UNITED STATES PATENT AND TRADEMARK OFFICE

09/437,296

Office Action Summary

DETAILED ACTION

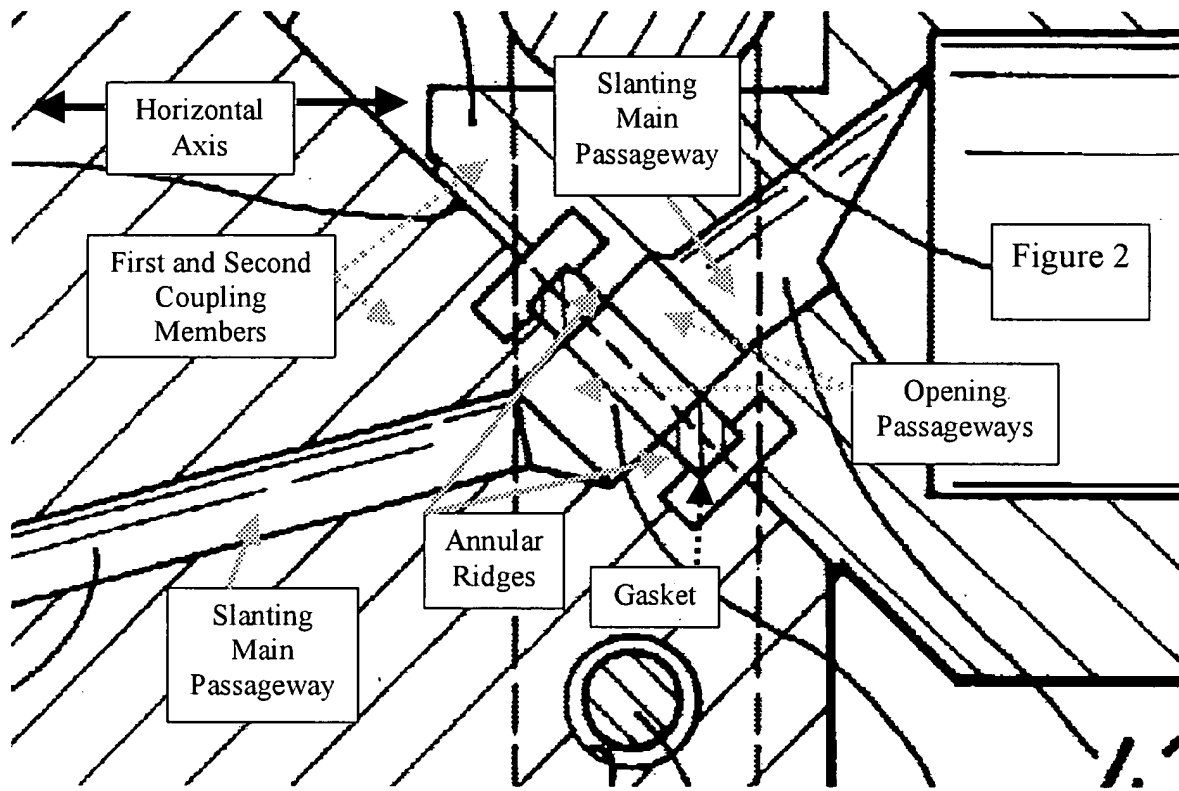
In regards to claim 1, in figure 2 below, as best understood, Nakazawa et al discloses a fluid coupling comprising first and second coupling members having respective gasket holding annular ridges on butting end faces thereof; and

an annular gasket interposed between the first and second coupling members, wherein each coupling member has a fluid channel comprising an opening passageway orthogonal to the butting end face thereof, and a slanting main passageway communicating therewith, the opening passageway having a diameter equal to the inside diameter of the gasket holding annular ridge, and

the gasket holding annular ridges are in contact with the gasket at its radial midportion so as (capable) to relieve the inner peripheral portion of the gasket from stress concentration and wrinkles.

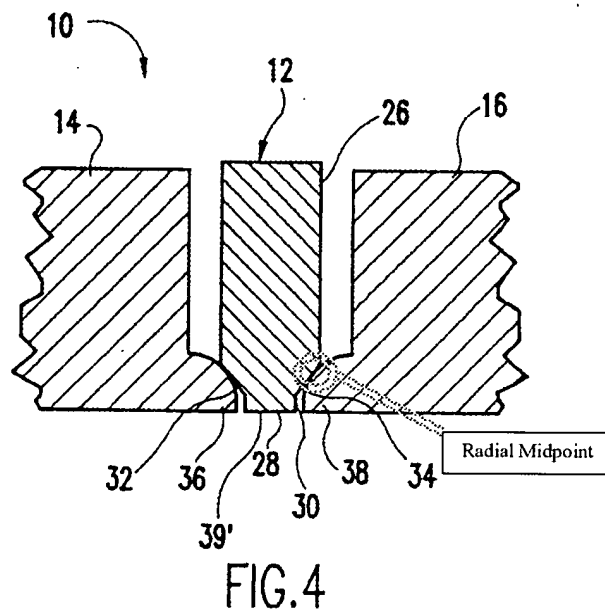
Applicant's arguments filed 12/9/2004 have been fully considered but they are not persuasive. The Applicant argues that in Figure 4 McGarvey fails to show gasket holding ridges which are rounded so as to be in contact with the gasket only at its radial midpoint. The Examiner disagrees.

In Figure 4 above, McGarvey clearly illustrates gasket holding ridges which are rounded so as to be in contact with the gasket only at its radial midpoint.
